Project	<b>IEEE 802.16 Broadband Wireless Access Working Group</b> < <a href="http://ieee802.org/16">http://ieee802.org/16</a> >	
Title	<b>Changes on inter-base station messages associated with handover</b>	
Date Submitted	<b>2004-03-17</b>	
Source(s)	Changjae Lee, Kiseon Ryu, Jay Jin LG Electronics, Inc. 533,Hogye-1dong,Dongan-gu, Anyang-shi,Kyongki-do,Korea	Voice: 82-31-450-4387 Fax: 82-31-450-7912 <a href="mailto:cjlee16@lge.com">[mailto:cjlee16@lge.com]</a>
Re:	Letter Ballot #14 on IEEE P802.16e/D1	
Abstract	This document contains suggestions to change the inter-base station messages associated with handover.	
Purpose	This document is submitted for review by 802.16e Working Group members	
Notice	This document has been prepared to assist IEEE 802.16. It is offered as a basis for discussion and is not binding on the contributing individual(s) or organization(s). The material in this document is subject to change in form and content after further study. The contributor(s) reserve(s) the right to add, amend or withdraw material contained herein.

# Changes on Inter-base station messages

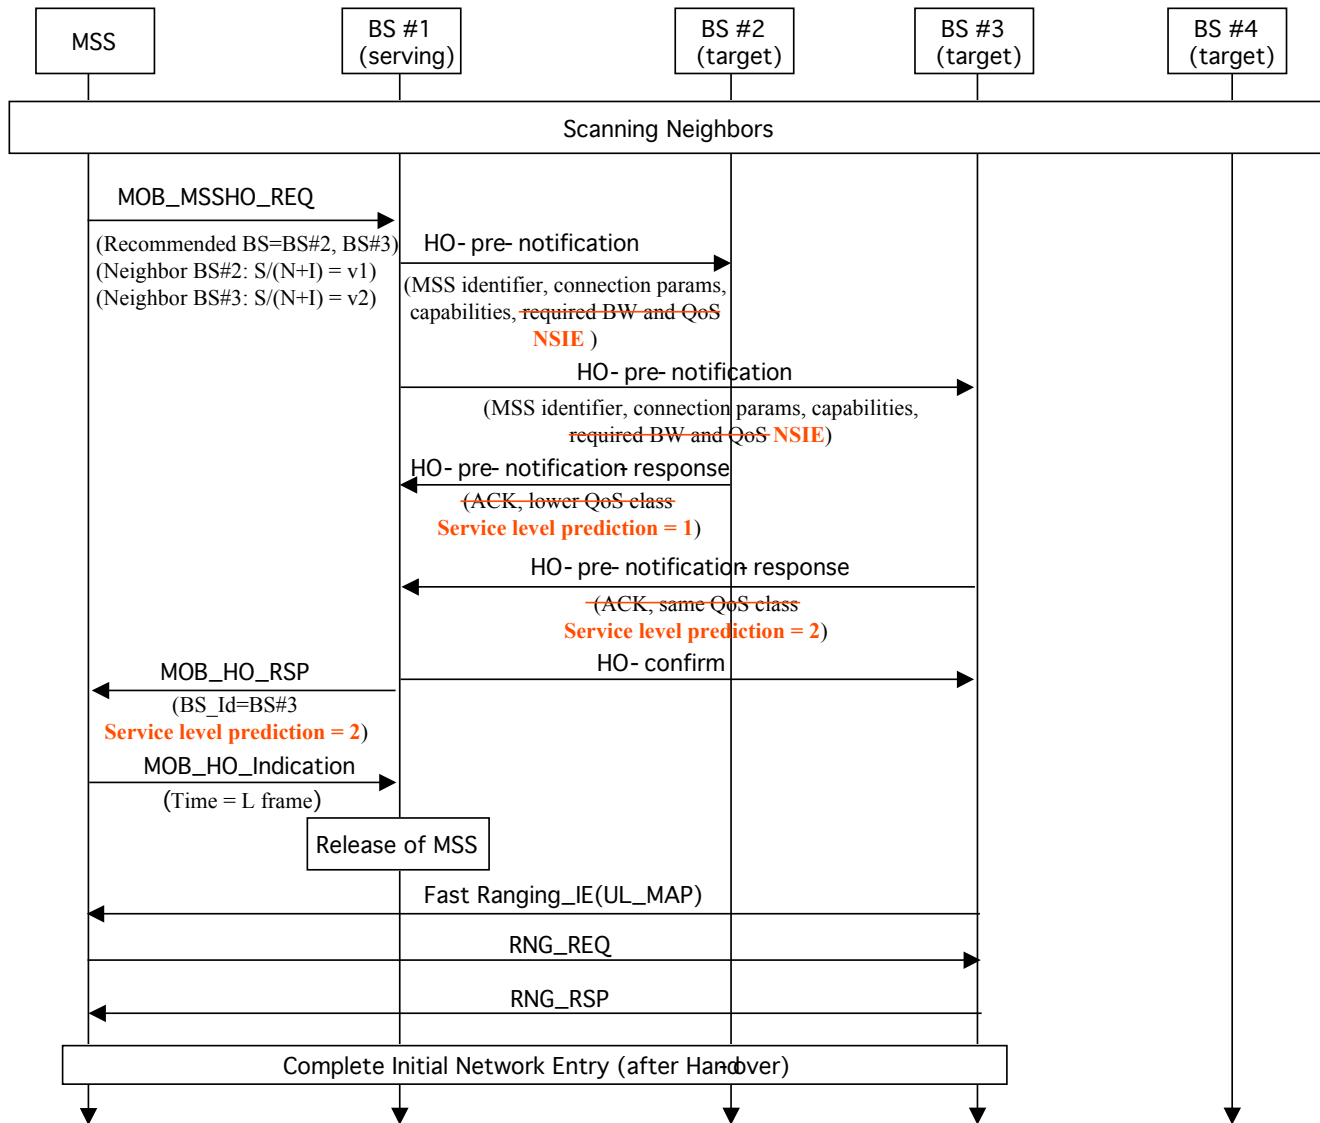
As specified in TGe Draft Document IEEE 802.16e-D1, “In the initial Network Entry, Ranging and Hand-over processes, MSS shall request from the Target BS certain QoS levels **per Active Service Flow, differentiated by Service Class available for the Service Flow**” and “As specified in 6.4.13.2. Service Flow ID has global meaning; it does not change in the process of handover.”

But there are some problems as followings:

1. SFID should be transmitted to Target BS during Hand-over, but Service Class Name does not include SFID
2. Service Class is a optional, so it can not used in global Hand-over because Service Class Name can not used globally.

1. We propose NSIEs (Network Service Information Element) in the HO-pre-notification message instead of Required BW/QoS parameters. NSIEs represent all Active Service Flow.
2. We also propose the Service Level Prediction parameter in HO-pre-notification-response instead of ACK/NACK indication.

The following figure-“HO process by MSS request” shows what the proposal is applied.
